MAGUBA VIADUCT
REVISED PLANS AND REPORTS

With reference to my telegram No.588 of the 18th December, regarding the Macupa Causeway, I have the honour to forward herewith in duplicate revised plans and reports submitted by the Chief Engineer, Uganda Railway, for examination by the Consulting Engineers.

MACUPA CAUSEWAY.

REPORT ON NAGUPA CAUSEWAY SURVEY & PROJECT.

DETAILS — SCALE. 10 FEET TO AN INCH. No. 3.

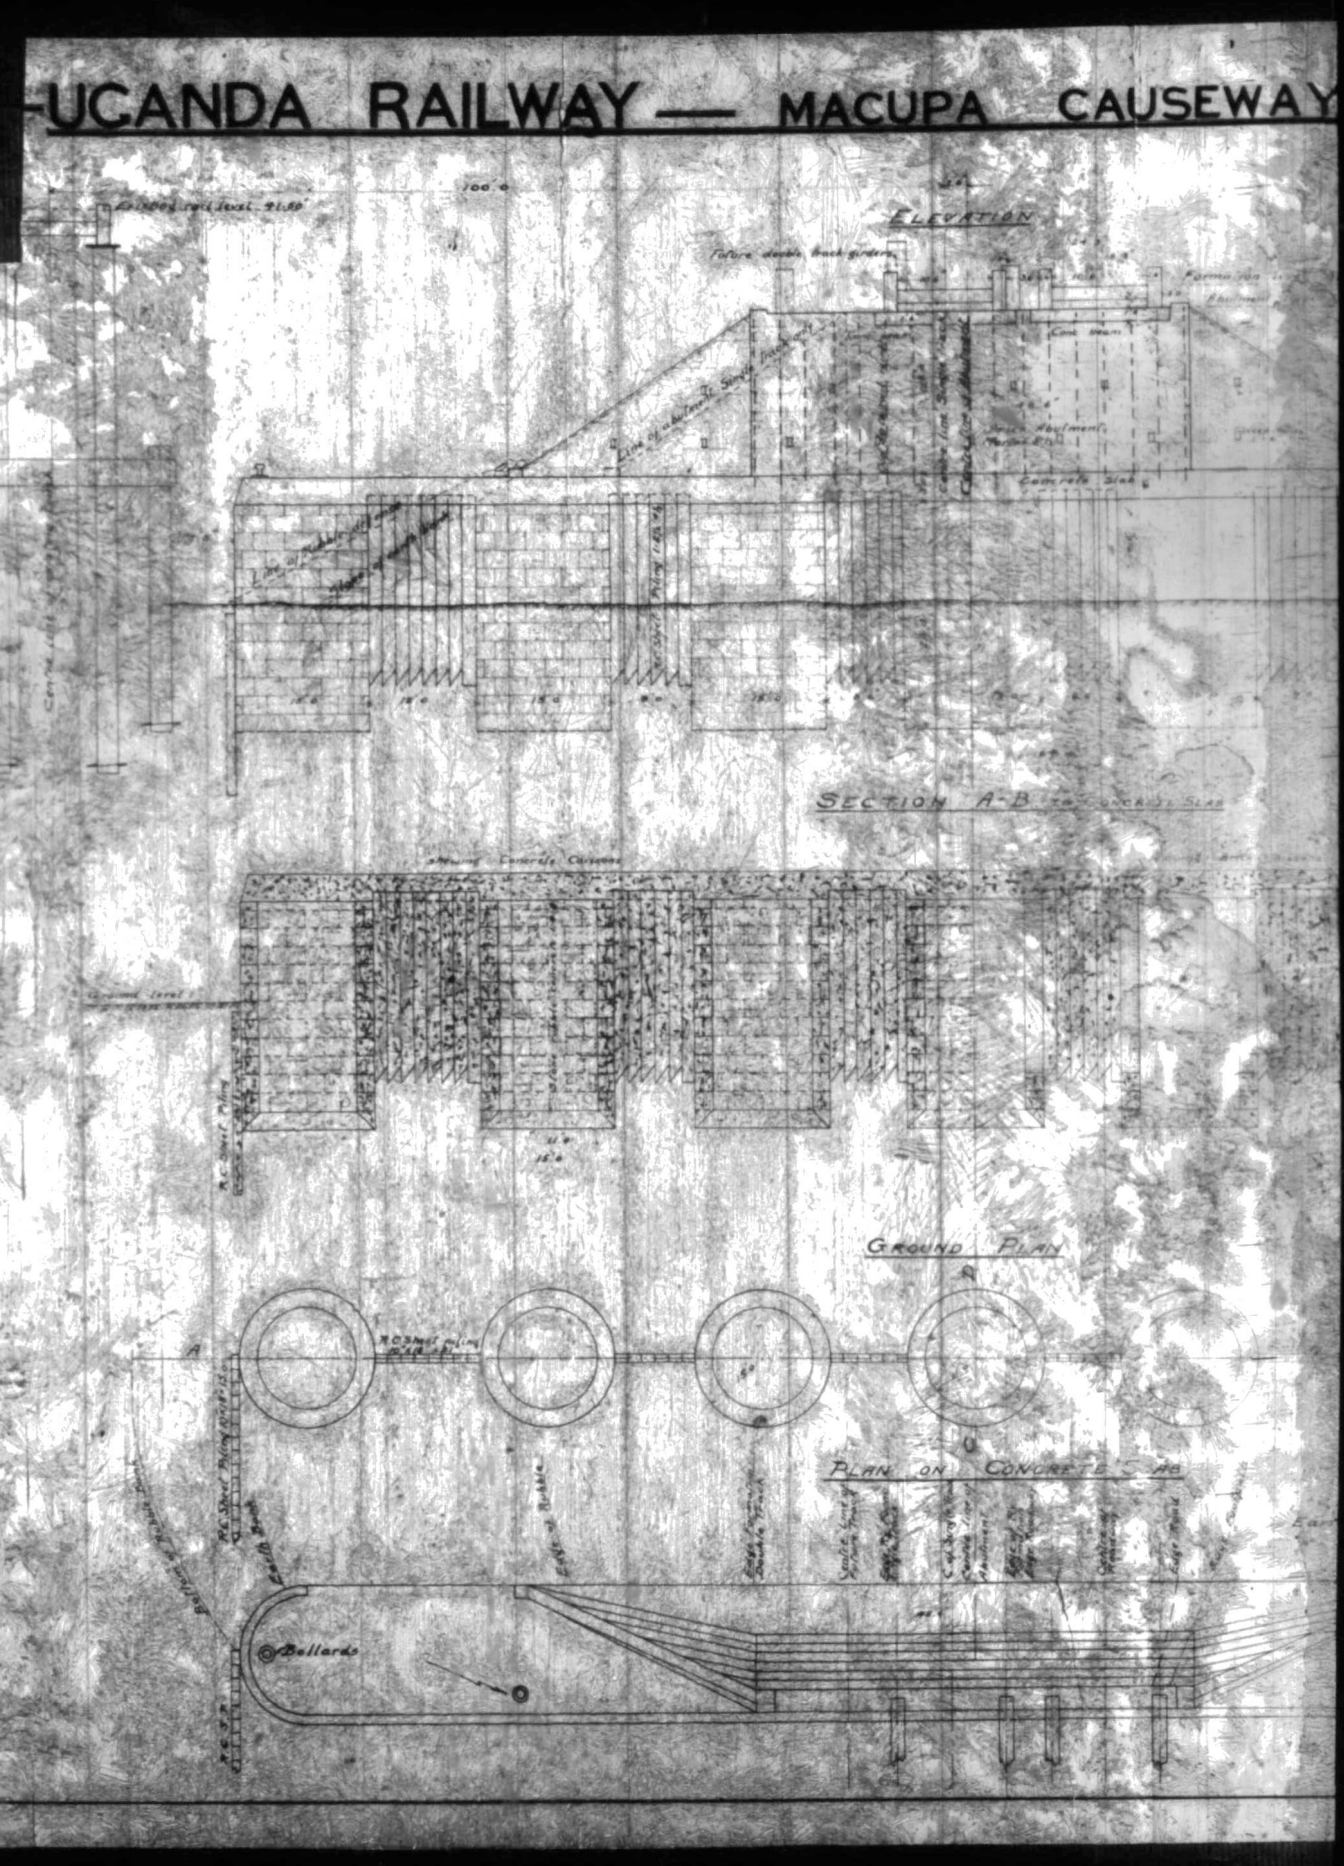
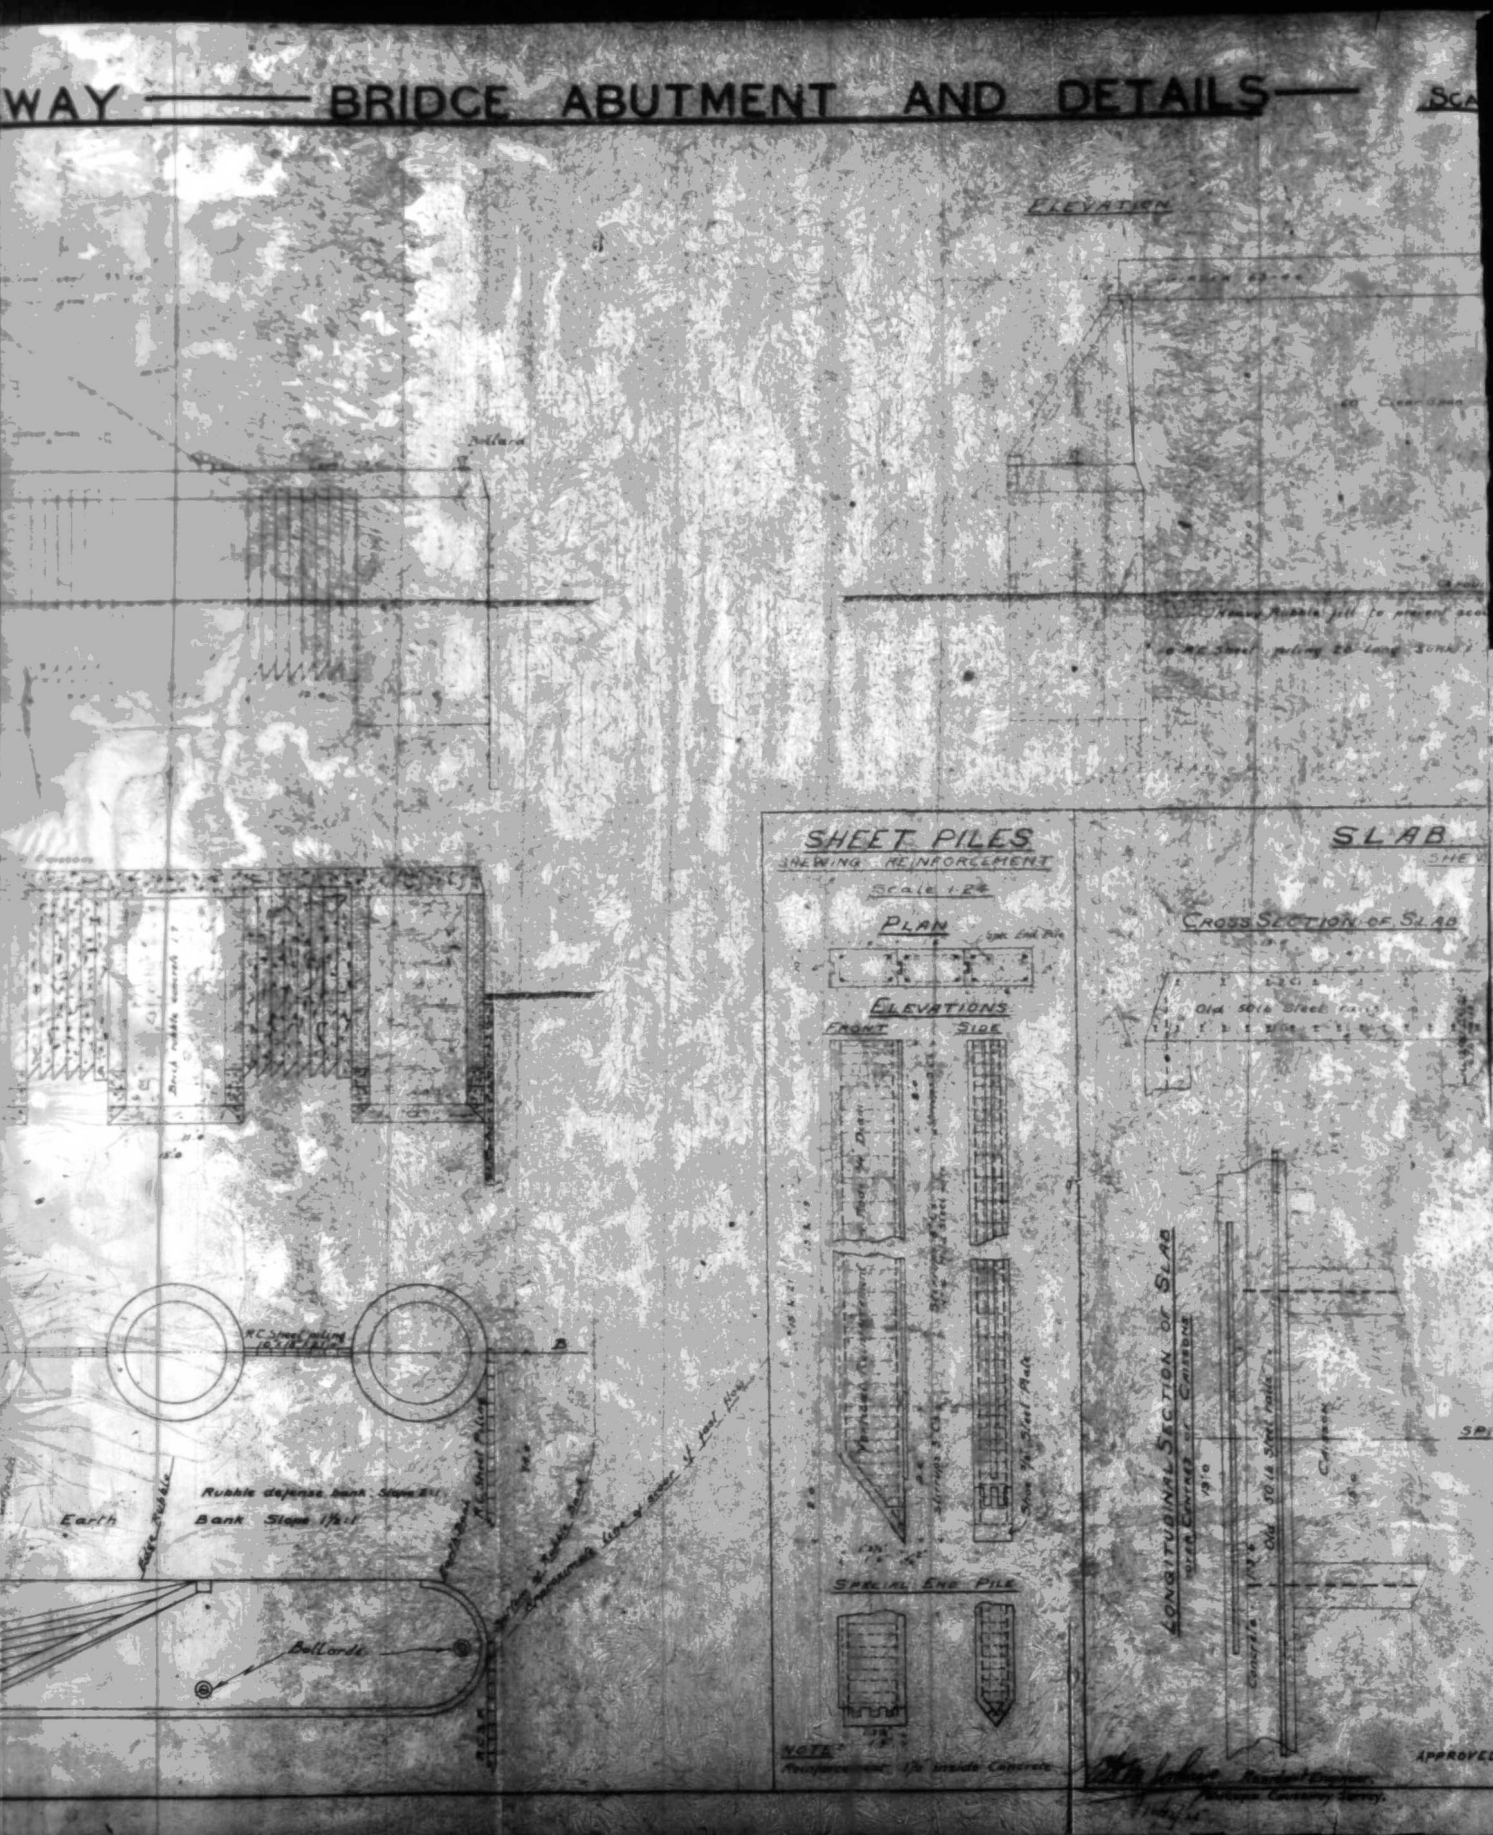
Para 5, page 2, Design of Bridge.

All calculations should be checked.
The design appears to provide ample bearing power, as low values for bearing and friction have been selected.

The question of over-turning should be carefully considered. Owing to the shape of the cylinders being circular the resistance to over-turning for the whole abutment is somewhat difficult to calculate accurately. The slab deck however is intended to bring all seven caissons to work in resisting over-turning.

The slab for this purpose will act as a beam and as such might be somewhat more scientifically reinforced. As a platform it is amply reinforced with old rails.

As pointed out in the addendum to the report the resistance to overturning can if necessary, be increased by moving the sheet piles out into line with the front face of the Caissons. I should like the Consulting Engineers opinion on these points.

Should the design and forces on Toe of Caissons not be considered to have a great enough factor of safety. An additional factor can be provided by moving the sheet piles out into a line with the front face of the circular Caissons.

On one abutment using friction only, at 3 tons per sq. yard. There is added an extra bearing power of 600 tons minimum to each abutment.

With regard to the overturning moment as shown in Plan No.5. The result would be that the moment would come well inside the middle third 5'8" from Toe.

The additional cost to the estimate would be Shillings 37,500.
